Company – See letter dated January 28, 2010 from Michael Horvath and attached Draft Report with First Energy's comments.

**Pennsylvania Department of Environmental Protection's Comments On:
Draft Report – Little Blue Run Dam Inspection Report
Bruce Mansfield Power Plant
Beaver County, Pennsylvania**

Assessment of Dam Safety Coal Combustion Surface Impoundments (Task 3) Draft Report

Bruce Mansfield
Power Plant
Little Blue Run Dam
Shippingport, Pennsylvania

Drawing Copyright © 2009  © Wilbur Smith, PO Box 5260 • Albany, NY 12205-0260 Main (518) 455-4000 • www.ch2m.com	TYPICAL CROSS SECTION	PROJECT NO.
		20085.8000
		DATE: 12/2009
		LITTLE BLUE RUN DAM SHIPPINGPORT, PENNSYLVANIA
		FIGURE 3

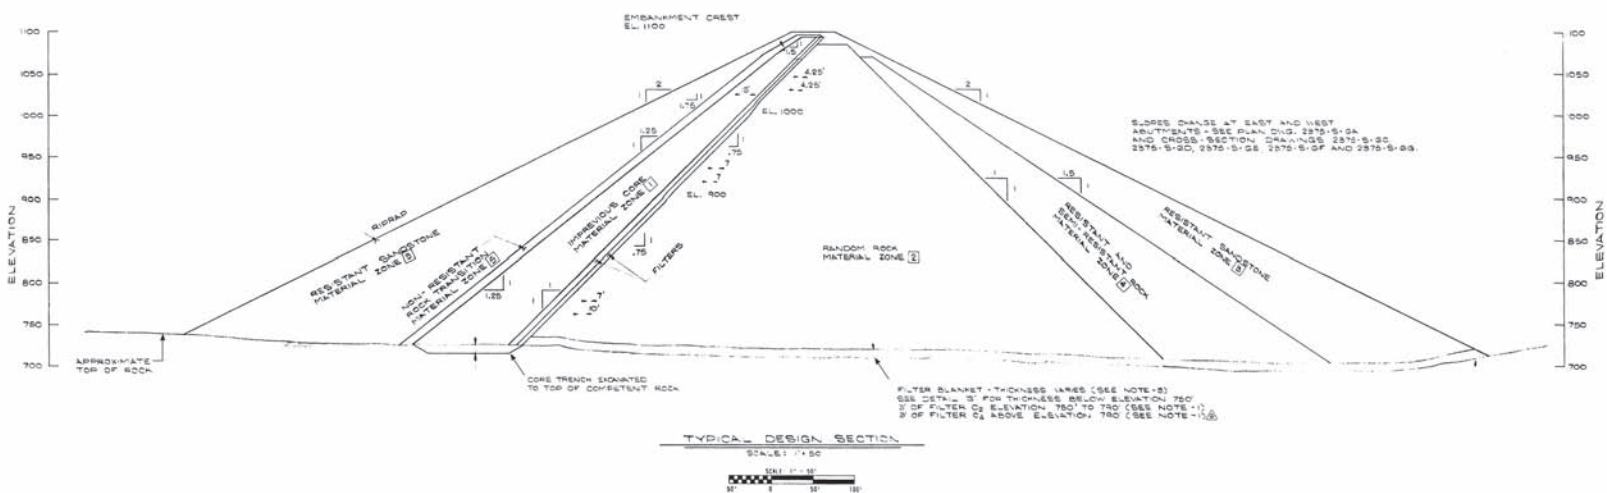
Insert following cross section. 1

SECTION A-A

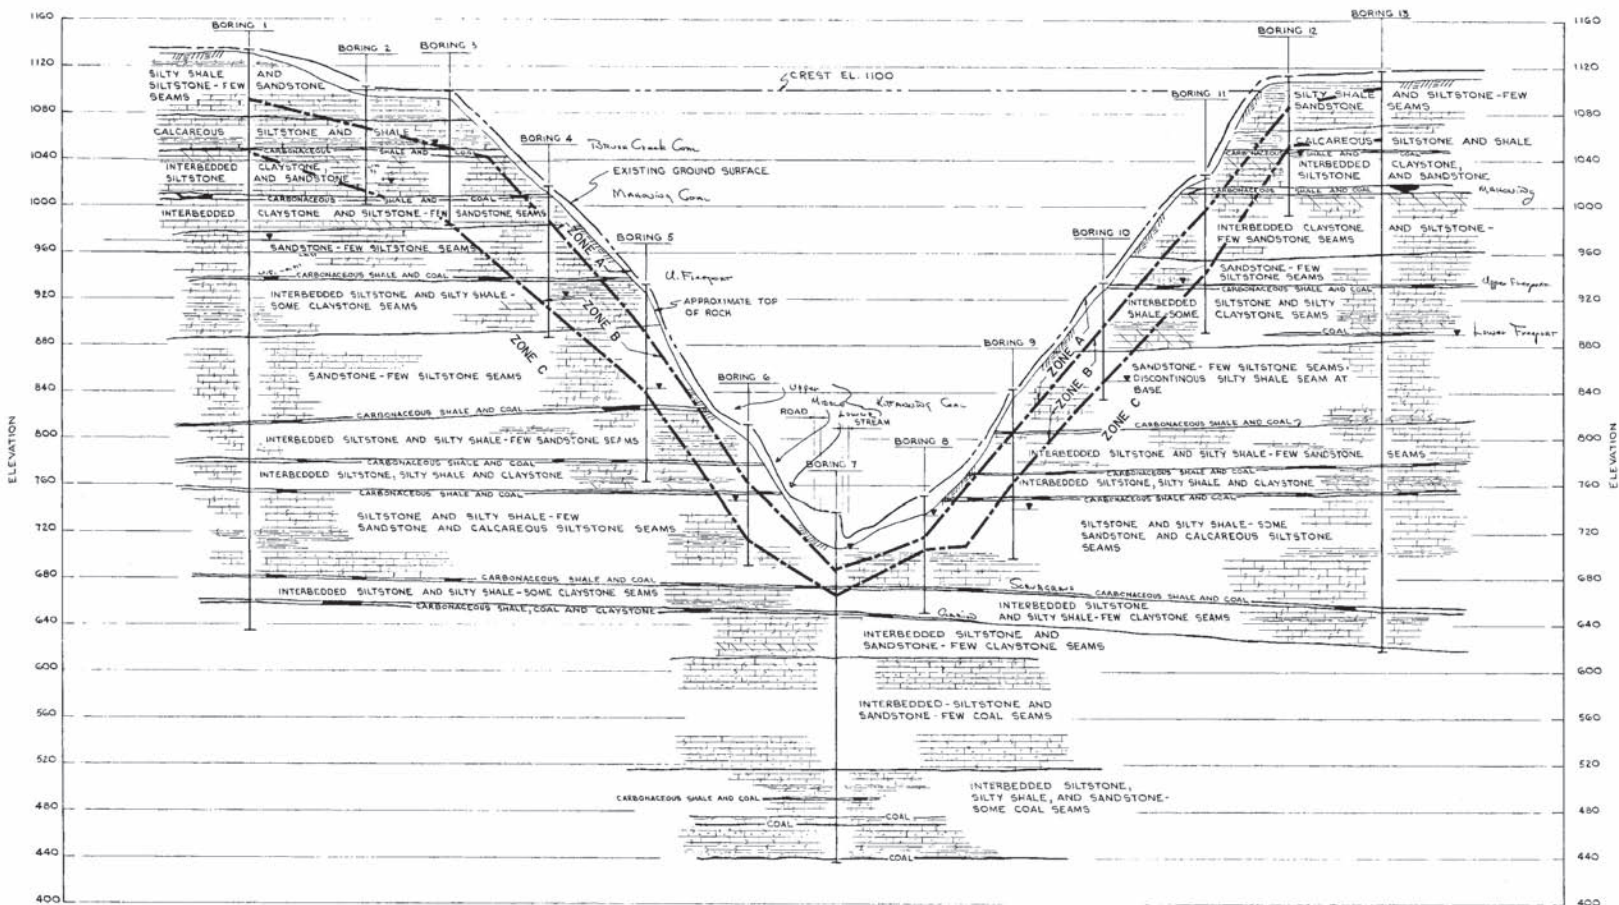
Insert following cross section. 2

SECTION B-B

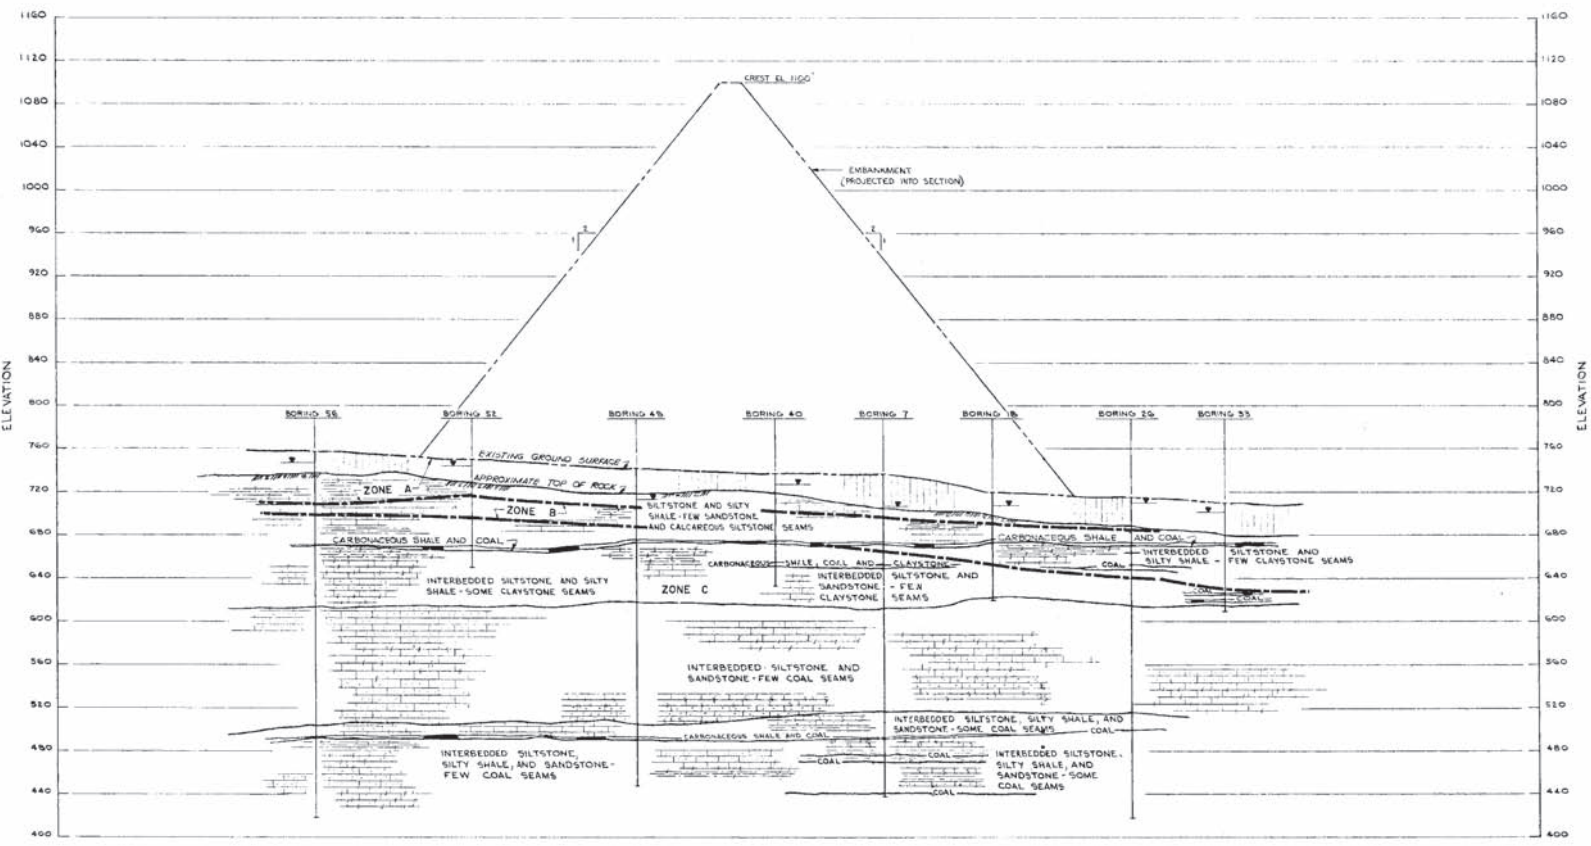
Insert following cross section. 2

PHOTO LOCATION MAP
 LITTLE BLUE RUN DAM
 SHIPPINGPORT, PENNSYLVANIA

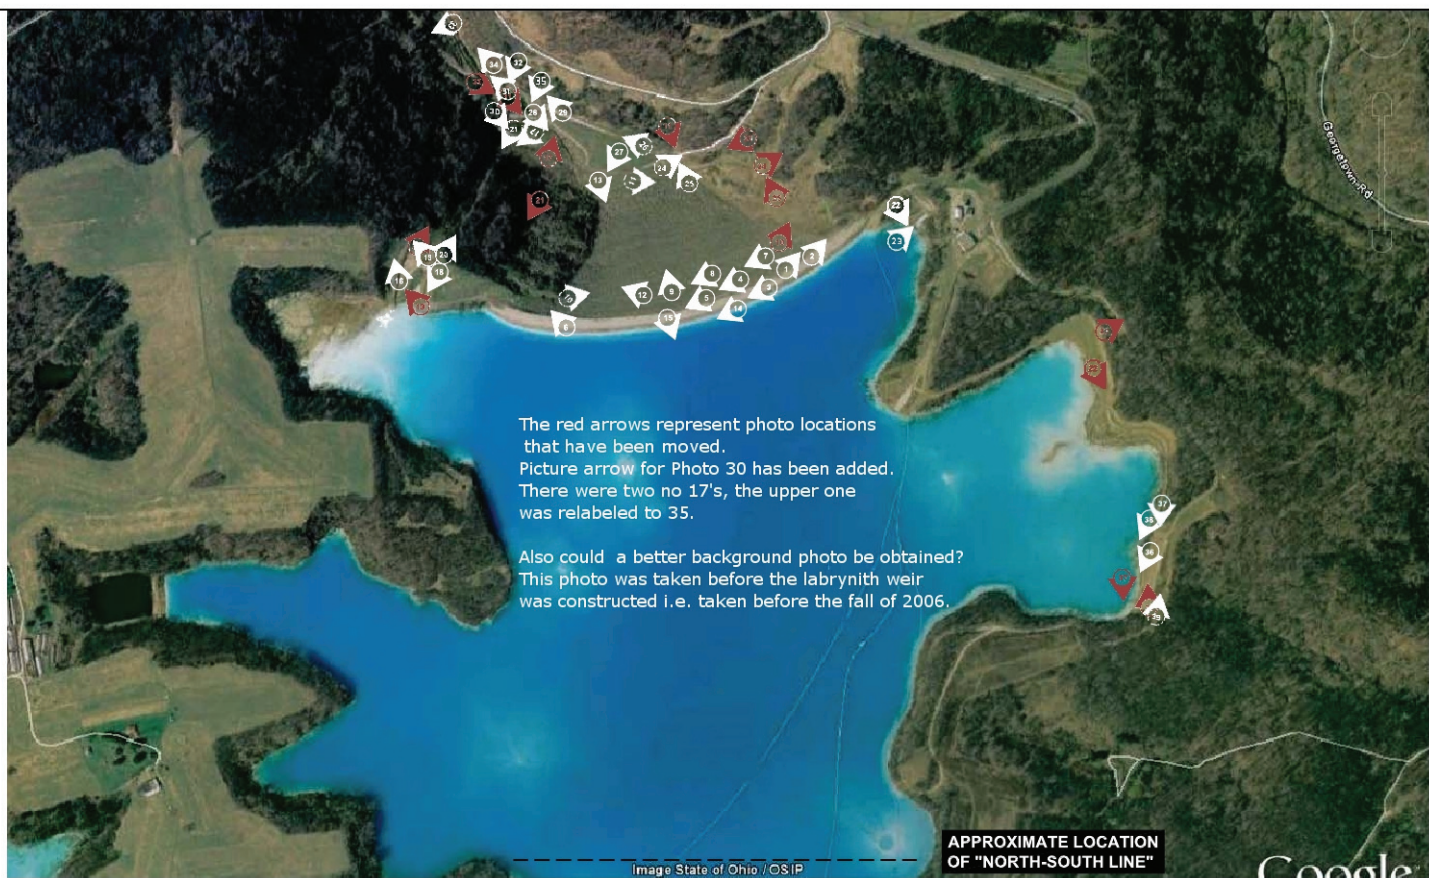
Replace with following page. 1

See note in center of picture. 1
